Groundwater Transfer Review Summary Form

Transfer/PA # T- 13504

Application: T-13504

Applicant Name: Port of Morrow

Figure 2. Water Level elevations in nearby wells

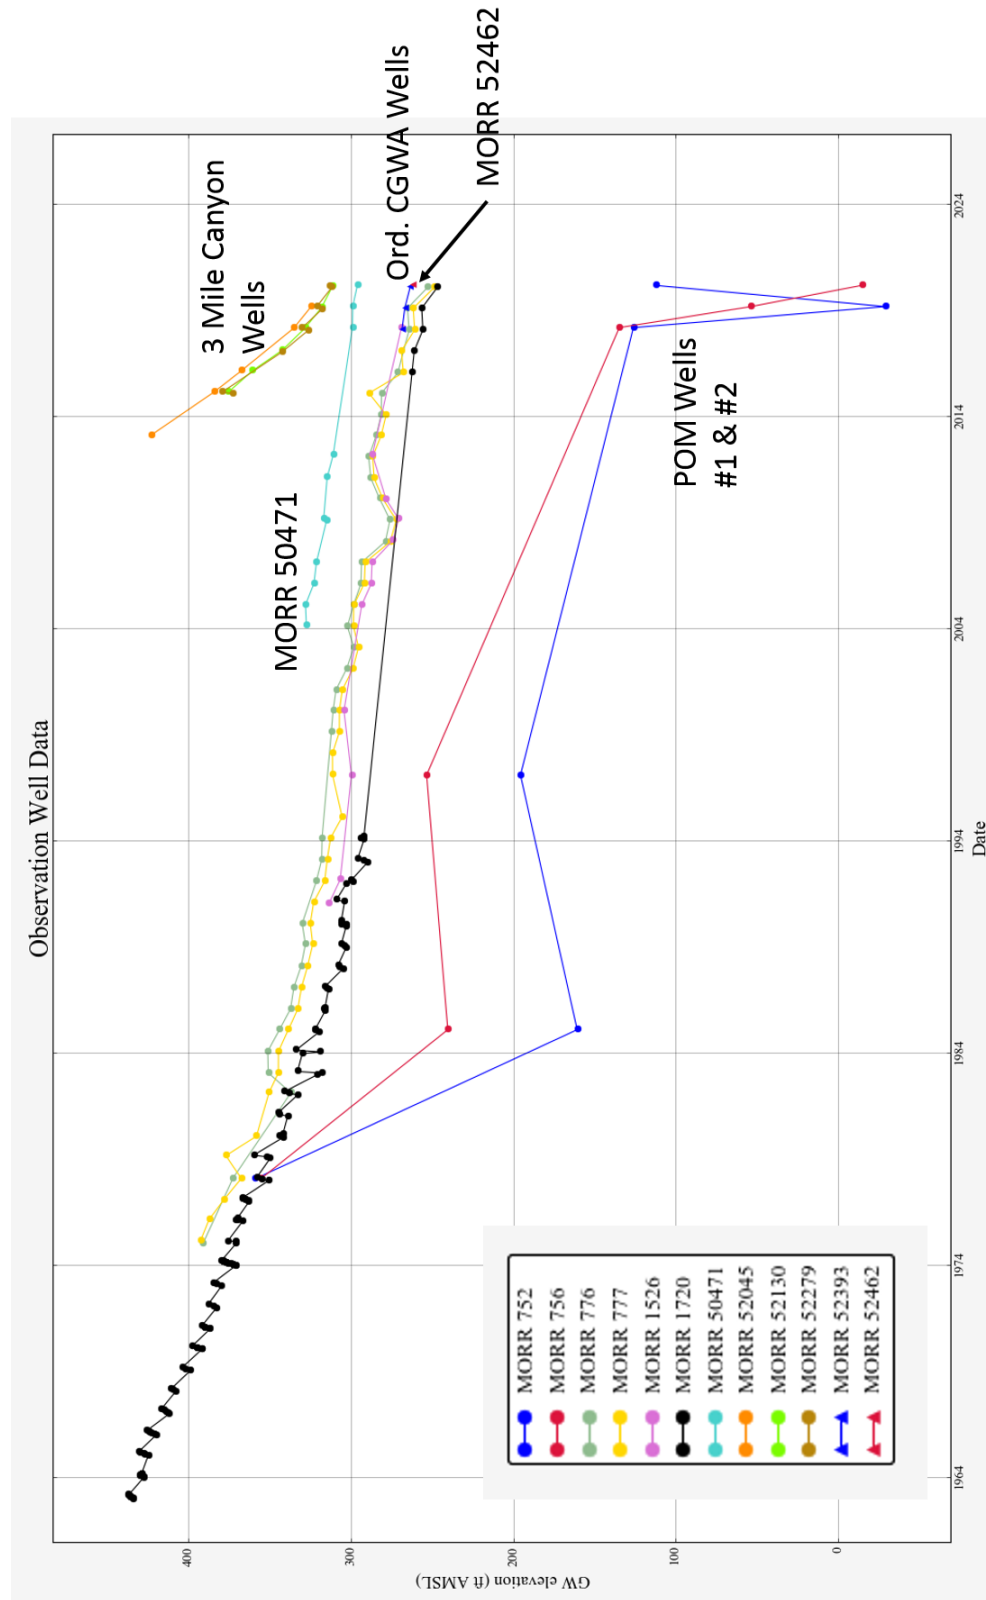
4. a) Will this proposed change, at its maximum allowed rate of use, likely result in an increase in interference with **another ground water right**?
 Yes No Comments: Proposed POA #5A/MORR 52462 is located approximately 7.5 miles east of the authorized POAs and about 1.5 miles west of wells in the Ordnance Deep Basalt Critical Groundwater Area (CGWA). While long-term water levels are not available for this well, it's most recent static water level elevation (March 2020) was coincident with wells in the Ordnance Deep Basalt CGWA and with POM Well #4 (MORR 1526) (see Figure 2). Although the water level in MORR 52462 is similar to nearby wells, it produces from a deep water-bearing zone not accessed by these other wells. Similar water levels suggests some hydraulic connection between shallower and deeper water-bearing zones, however, the efficiency is uncertain.

Figure 3. Distance drawdown estimates for the proposed change.

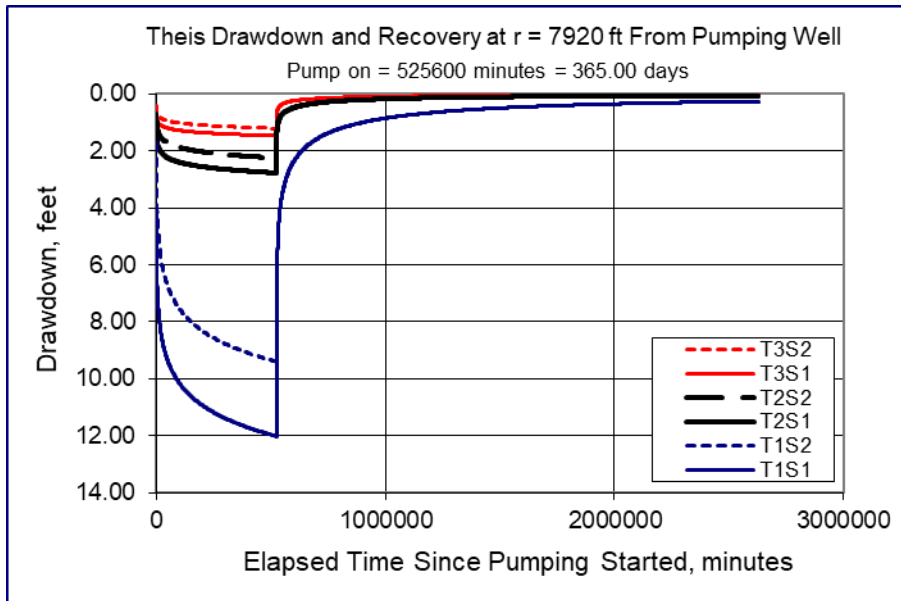
- b) If yes, would this proposed change, at its maximum allowed rate of use, likely result in another groundwater right not receiving the water to which it is legally entitled?
 Yes No If yes, explain: Based on a range of reasonable aquifer parameters, drawdown from MORR 52462 at a distance of 1.5 miles ranges from 2 to 12 feet after 365 days of pumping at the maximum permitted rate of 2226 gpm (see Figure 3). There are tens of feet of available head at nearby wells, indicating the increased interference will not prevent neighboring wells from accessing their water.
